REVIEWER 1

This paper presents a useful description of how JANUS observations were planned for the unique double gravity assist flyby JUICE performed in 2024. Such details are often lost in papers focussed on the results of observations, and it is good to see the effort that goes into making the observations carefully described. The paper is well written and clear, and I have only minor comments and suggestions that the authors may choose to implement. I give them by line number:

The article by Tubiana et al. describes observations of the JANUS camera system during LEGA. Its purpose (in my view) is to provide an overview for science and calibration to be performed on this data set and provide an exemplary template for coming (Jupiter system) observations. I consider instrument operation during cruise essential and much appreciate the effort to provide a clean article like this.

Histogram of three subsections of JANUS images in Figure 4. Each subpanel contains 150x140 pix and represents the same area although observed on a slightly different time from a slightly different perspective.

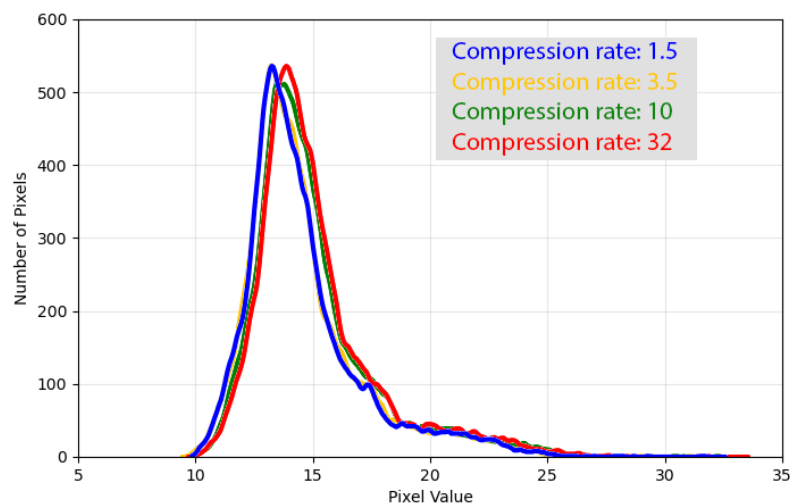
L165-170: I realise that the authors say that the results of the compression test are preliminary, but I wonder if there is any way that they can show how well photometric accuracy is preserved? I agree that there is no visible degradation of the image quality with compression, but are pixel-to-pixel brightness variations affected? Perhaps showing some image histograms for the lower panels of fig 4 would be a way to do this? Alternatively, if a more detailed analysis is planned, perhaps the authors can simply cite the (in prep?) paper that will look at it.

Fig. 4: Several issues keep me from judging the quality. First, I do not know the pixel size and processing steps applied to the bottom line. I assume that compression acts like a smear. Is this correct? That depends on the actual compression algorithm applied, which is not provided. I would be able to see compression artefacts only if I can see individual pixels. Zooming into the image, Firefox & Adobe Reader seem to apply some sort of filtering (Lanczos or such). That’s how far I went. Please provide some more information.

REPLY: A quantitative analysis of the effect of compression on the image quality and the photometric accuracy is planned and will be carried out in the next months, but it is not yet ongoing. We have modified the figure to show three images with compression ratios of 1:1, 3.5:1, 10:1 and 33:1. Compression effects are very small at small to moderate compression rates and some degradation is observable at compression rate 10, with sharp horizontal and vertical

lines that are added over the structures in the images. Since lunar images have very strong contrast these lines are better observed when displaying a high-pass filtered version of zoom-up versions of the images (bottom row in figure 4). A very strong compression ratio of 33:1 produces strong artifacts that degrade the visibility of small craters present in the images. Radiance values from these images are nearly identical and histograms of common regions in the images show nearly identical results. We believe including histograms of these images is not needed as rows 1 and 2 in Figure 4 are shown using exactly the same radiance range showing strong consistency in the pixel values. Histograms of the four small panels in row 2 in Figure 4 are given below but we think adding those histograms in the manuscript would remove part of the focus. We have updated the figure and text in the manuscript. We have also updated statements in the manuscript about future observing strategies and data.

REPLY: info about the compression alghoritm added in the camera description (line 68, added: JANUS is equipped with a compression unit that compresses the data using a standard wavelet compressor, allowing both lossless and lossy compression up to a factor 33:1.). Additional
